Alamogordo City Commission

Regular Meeting Agenda

June 14, 2022 - 6:30 PM
City Hall, City Commission Chambers
1376 E. Ninth St.

17. Consider, and act upon, approval of Resolution No. 2022-28 adopting the revised Technical Standards as minimum requirements for the design and construction of subdivisions, City utilities, streets, and improvements inside the public right-of-way. *(Nancy Beshaler, Public Works Director and Rusty Payne PE, Smith Engineering Company)* **(Roll Call Vote Required)**

ISSUE DATE:	JUNE 14, 2022
RESOLUTION NO:	2022-28
REVISION DATE:	----
SHEET NO:	S-20

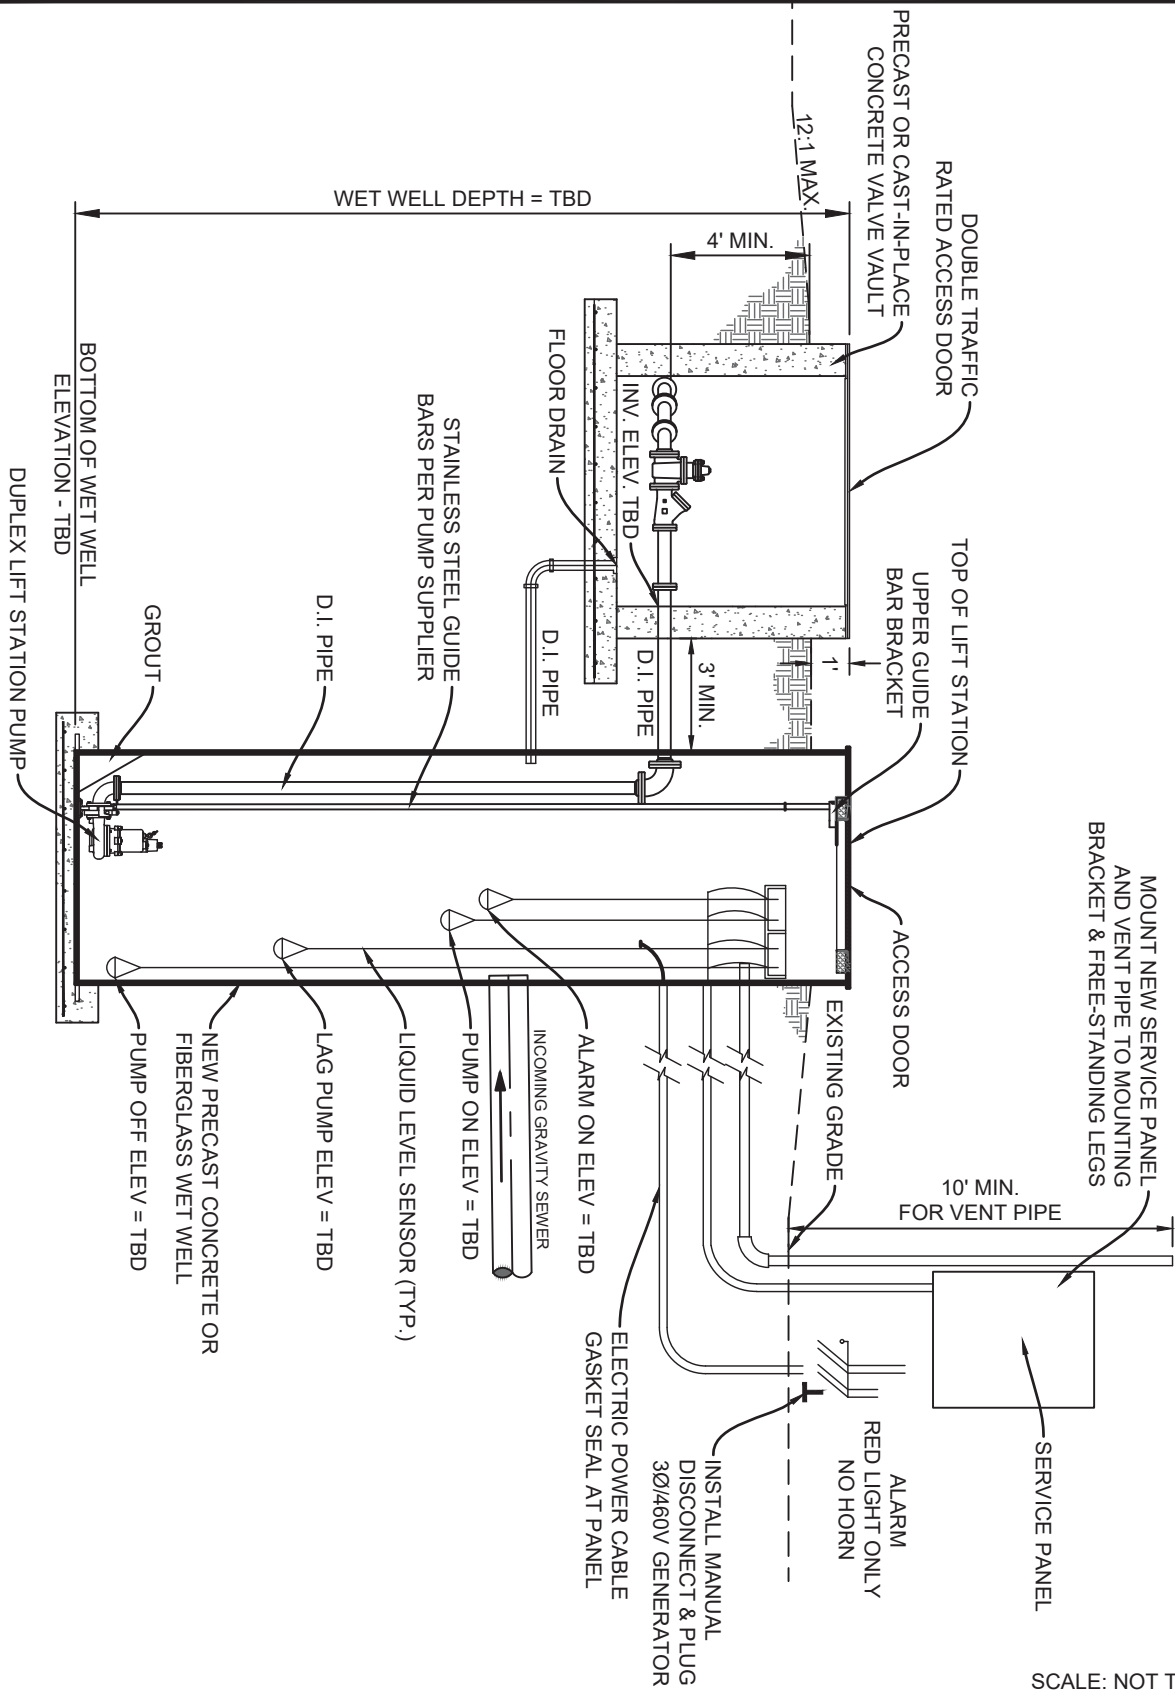
Comment: Standard Detail S-20 – Rebar in clean-out collars is very excessive!

ISSUE DATE:	JUNE 14, 2022
RESOLUTION NO:	2022-28
REVISION DATE:	----
SHEET NO:	W-7

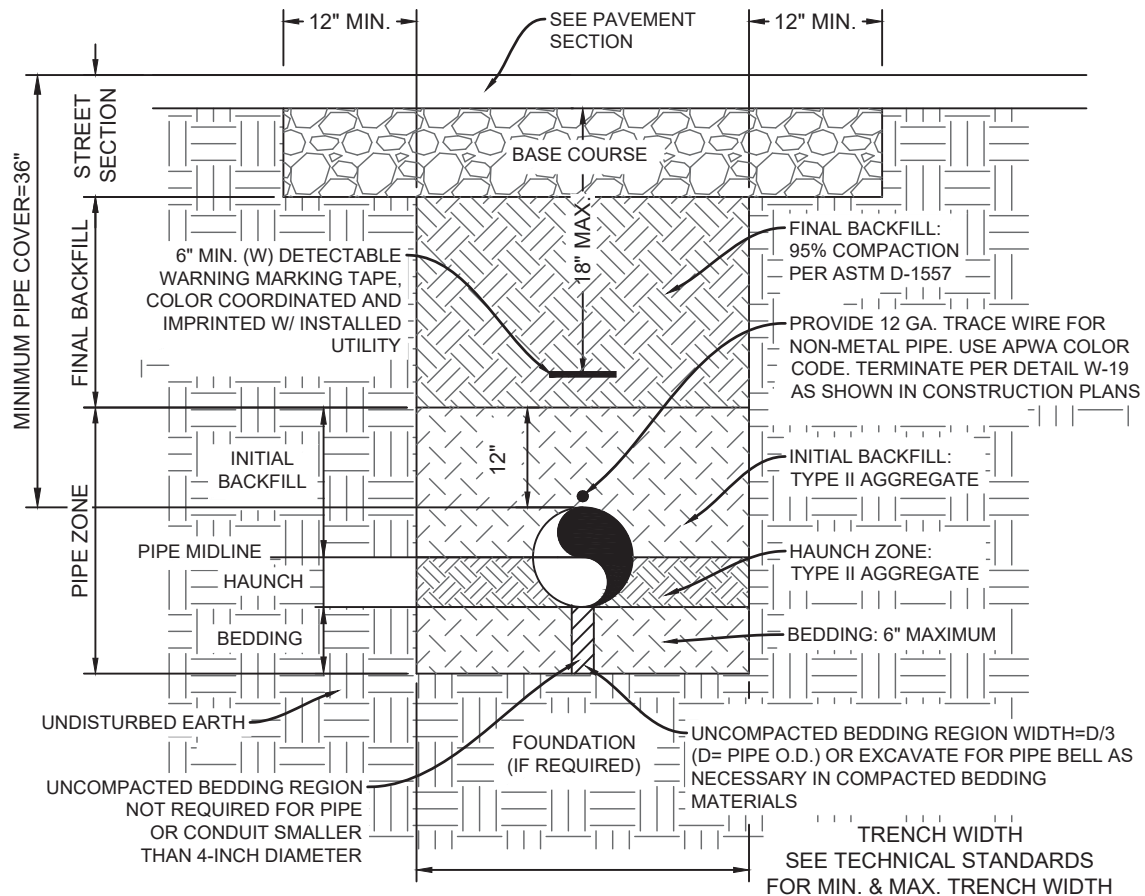
Comment: Standard Detail W-7 – Rebar mat in a simple valve collar is way too excessive!
